**RE:** *Critical Area Narrative Report – Variance Application for Detached Garage*

**Property:** 1604 Pine Lane Retreat, Annapolis, MD 21409

### CONFIRMATION OF PRE-FILE

**PRE-FILE #:** 2025-0072-P  
**DATE:** 07/31/2025  
**OPZ STAFF:** Jennifer Lechner  
Kelly Krinetz  
Stacy Poulos

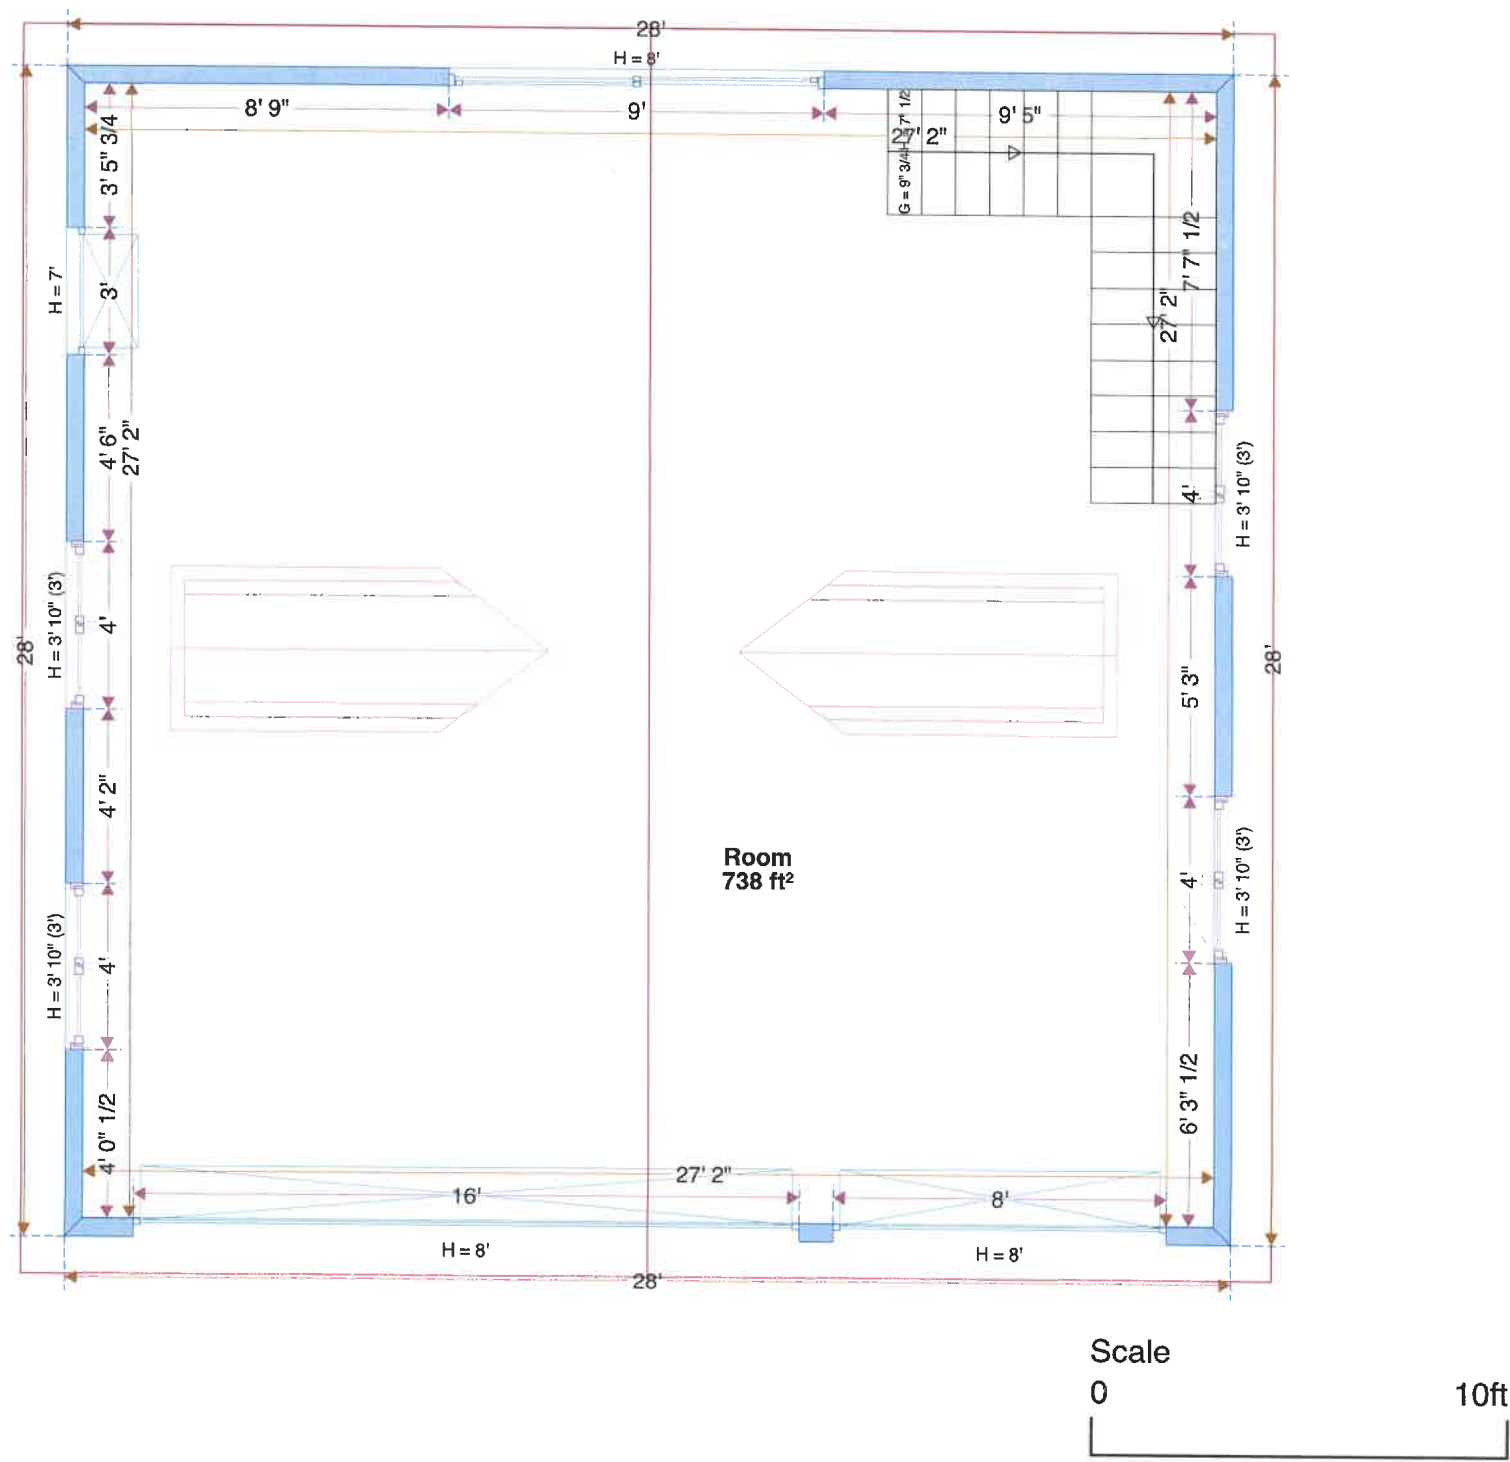
Concurs with the Critical Area Team. The proposed accessory structure does not appear to represent the minimum necessary to afford relief. A 30' x 30' garage with a 6' x 30' overhang seems excessive at the top of steep slopes and within the expanded buffer.

- The zoomed detail view, as submitted, is appropriate due to the size of the property. However, the site plan should also show the entire parcel. This would depict the extent of the slopes and expanded buffer on the property.
- Accurately note the R1 accessory structure setbacks.
  - Per § 18-4-501, in an R1 District, the minimum setbacks for accessory structures are:
    - Front lot line = 50 feet
    - Side and rear lot lines = 15 feet
- The distances to the rear and side lot lines should be measured, and noted, as a straight line drawn perpendicular (90 degrees) from the lot line to the proposed garage.
- The height of the proposed garage must be included on the site plan (i.e., noted with the 30'x30' dimensions).
